**Peer Review of**

**Visual Impact Assessment**

**Hunsberger Pit**

February 2010

Figure 3  
Hunsberger Pit Phasing Plan

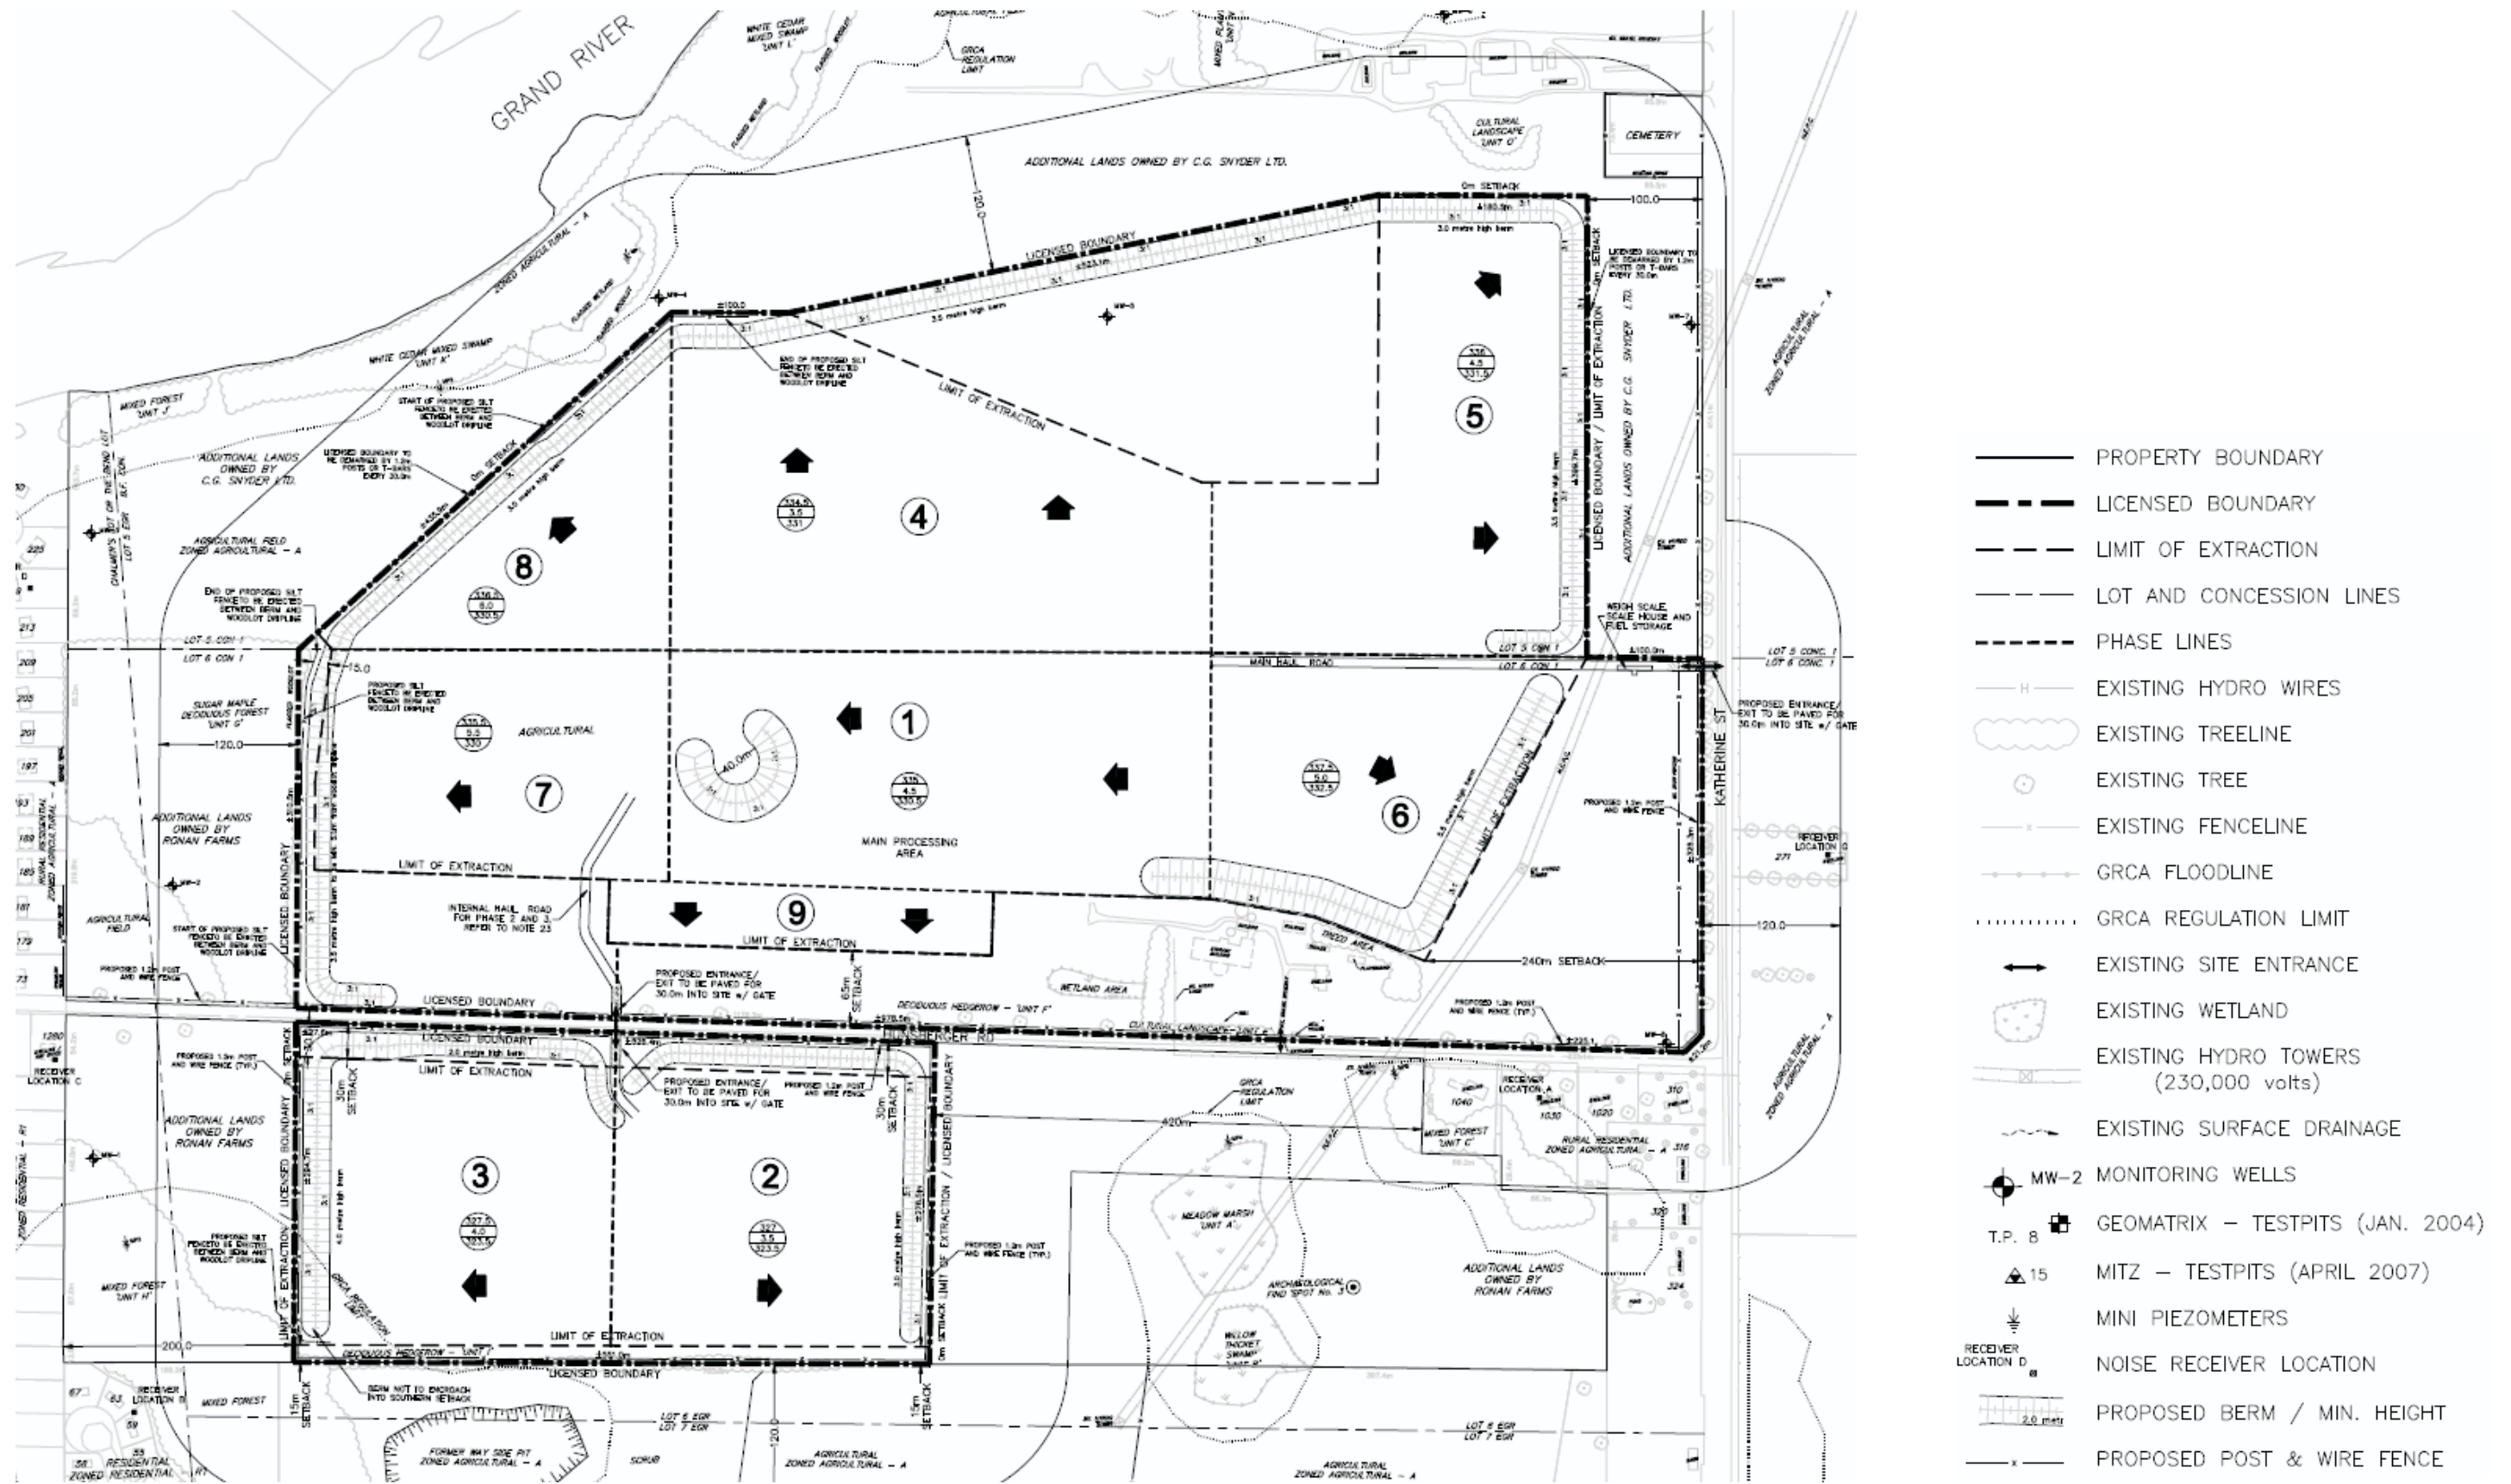
Fifth Bullet: Elevation at Hunsberger Road or the elevation at which the proposed 2 metre berm will be constructed along the frontage of Phase 2 has not been provided. The height of the berm should be sufficient to mitigate the potential visual impact from the proposed operation to passing vehicle passenger or hiker.

Fourth Bullet: The Separation distance from the residence at 1280 Hunsberger Road property line to the limit of extraction is 200 metres, not between 200 and 300 metres. This same residence is referred to as 280 Hunsberger Road instead of 1280 Hunsberger Road. The berm referenced to in this paragraph as being 2.0 metres in height is shown on the “Operational Plan” as being 4.0 metres in height.

Figure 4  
 Grand River Conservation Authority  
 Grand River Trail  
 Township of Woolwich  
 Region of Waterloo

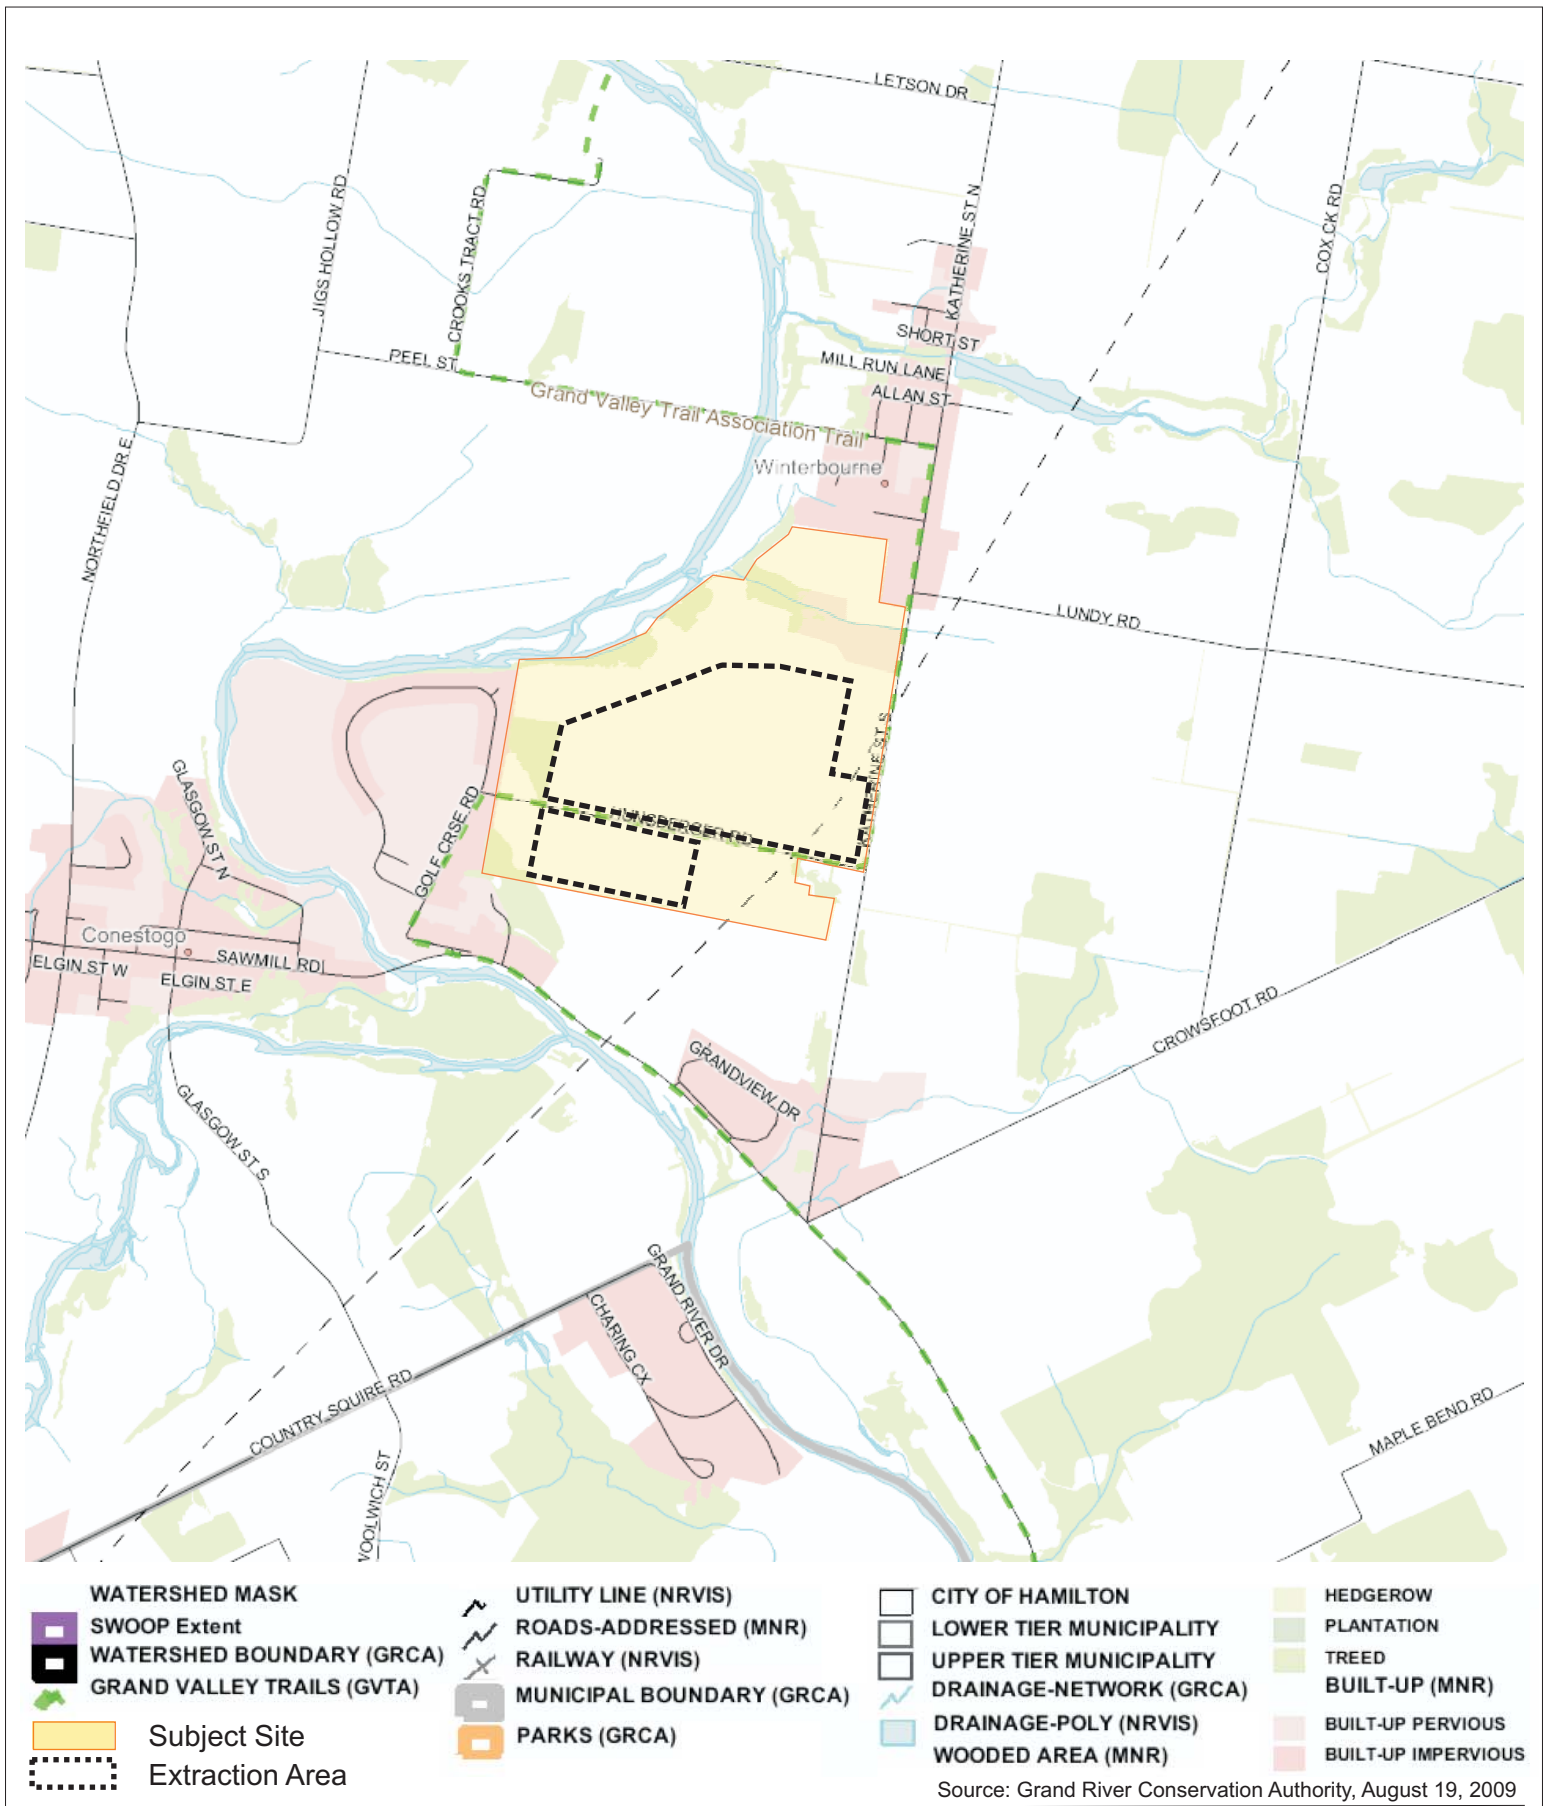
In relation to the Subject Properties the Grand Valley Trail, runs along the entire east edge of the northern portion of the Subject Properties along Katherine Street (Regional Road 23), and along the entirety of the Hunsberger Road frontages of the pit operation.

Trail hikers traveling south will be exposed to a direct line of sight of Phase 2 and 3 of the operation as well as the traffic generated by material being hauled to the main processing area in Phase 1. The elevation of Hunsberger Road west of Katherine Street at an approximate elevation of 335 metres provides a clear view of Phases 2 and 3 which will occur at an elevation approximately 10-15 metres lower. The rural character of Hunsberger Road along this segment and the visual impact to the trail users should be addressed by the applicant.
